FINAL ORDER

Special Standards Request Form

15575 SW Sequoia Parkway - Suite 100 Portland OR 97224 Off 503.968.8787 Fax 503.968.3068	LRS-10-02	WELL VAULT DETAIL	
	FEBRUARY 2011	PROPOSED EAST MULTNOMAH COUNTY COURTHOUSE PORTLAND, OR.	RFI NO. 003

- (7) Diagram showing the pertinent features of the proposed well design and construction:
(attach additional pages if needed)

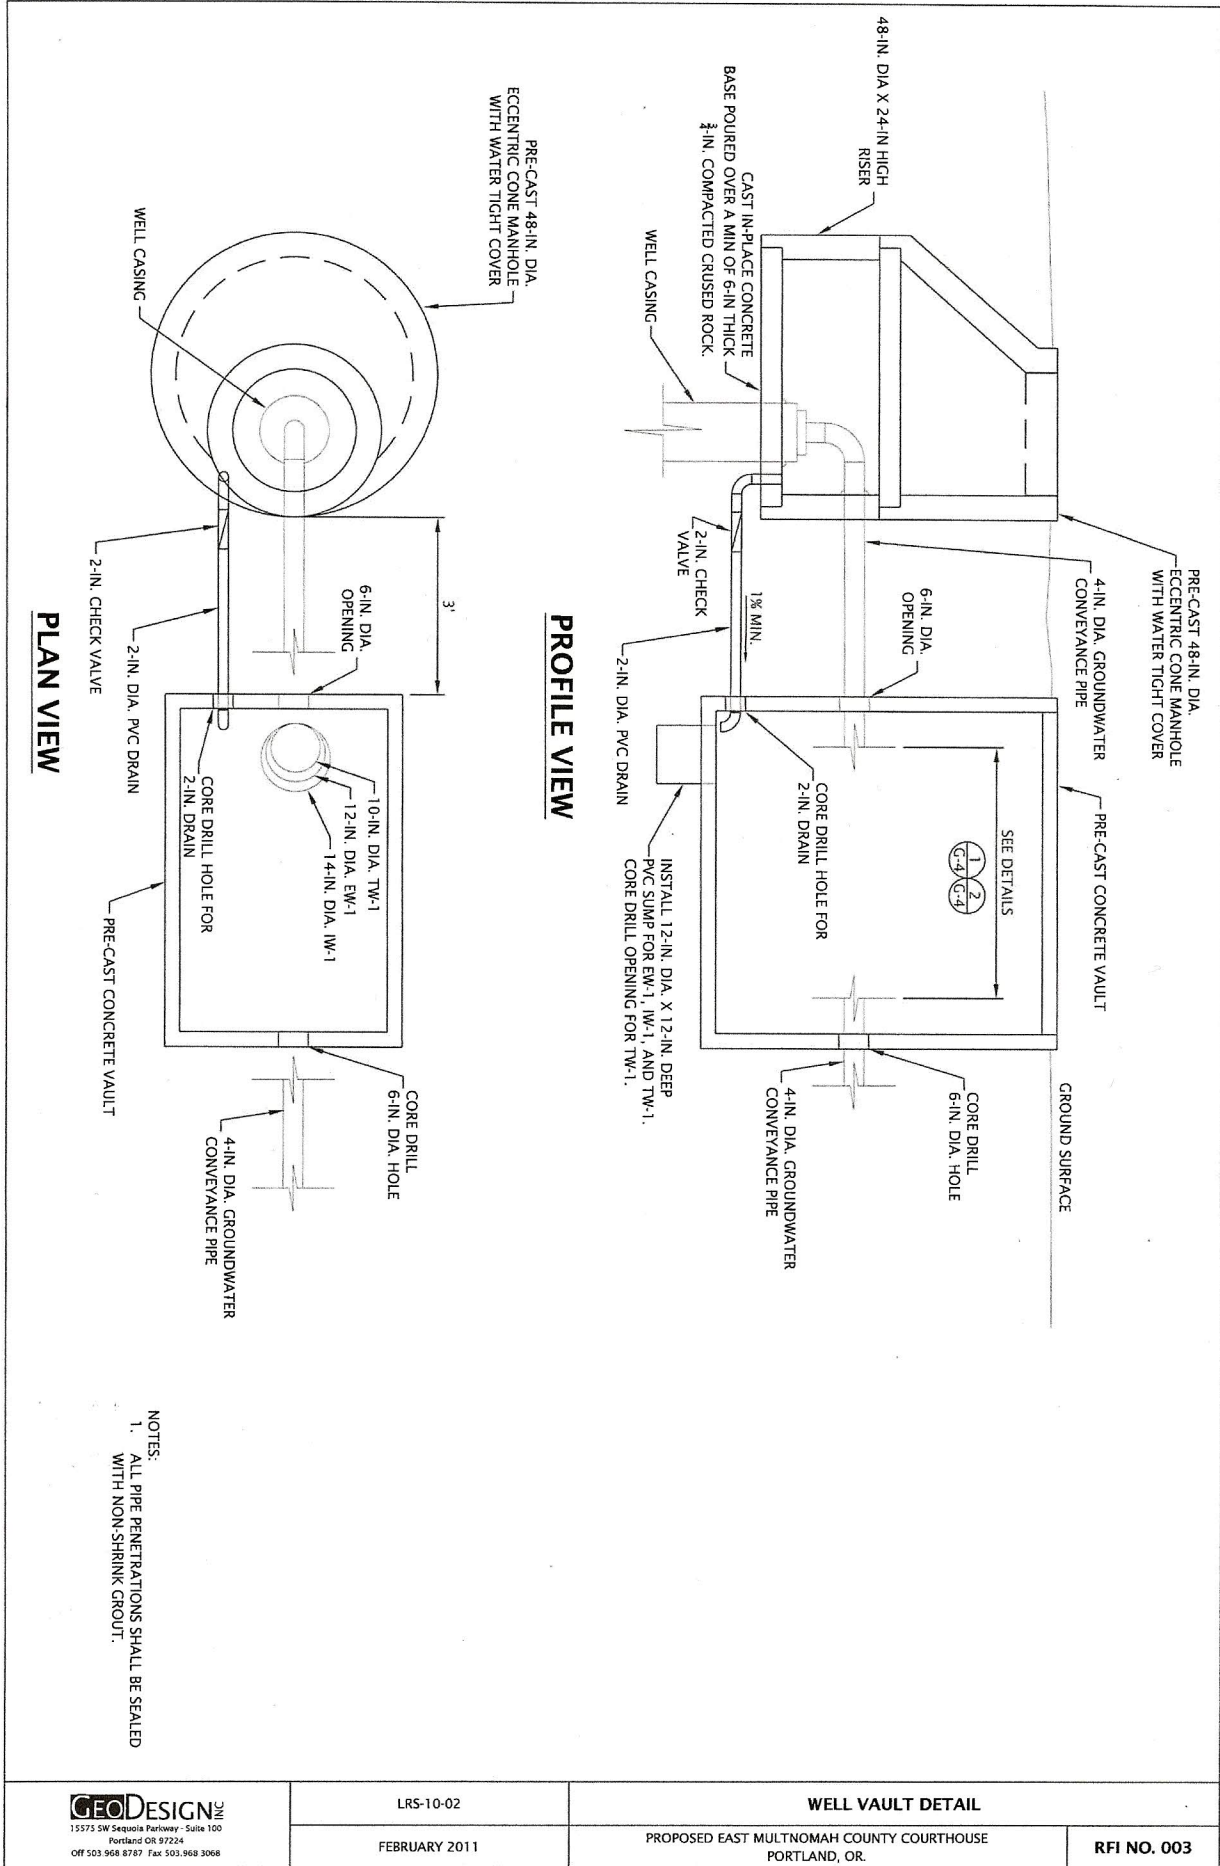
The Special Standard request you submitted for owner: Multnomah County, Start Card number 1012280, is hereby approved for the following: You may install this well below land surface in a vault. The vault must be constructed per the design diagram included on your request. All conduit and pipes entering the vault must be sealed to prevent surface water from leaking into it. The vault also must have a drain to daylight with a check valve to prevent backflow. ***In addition, the lid of the vault shall be permanently marked with the words "Water Well" in order to protect the groundwater resource and to assist Department personnel in locating the well in the future.*** All other construction standards must be adhered to.
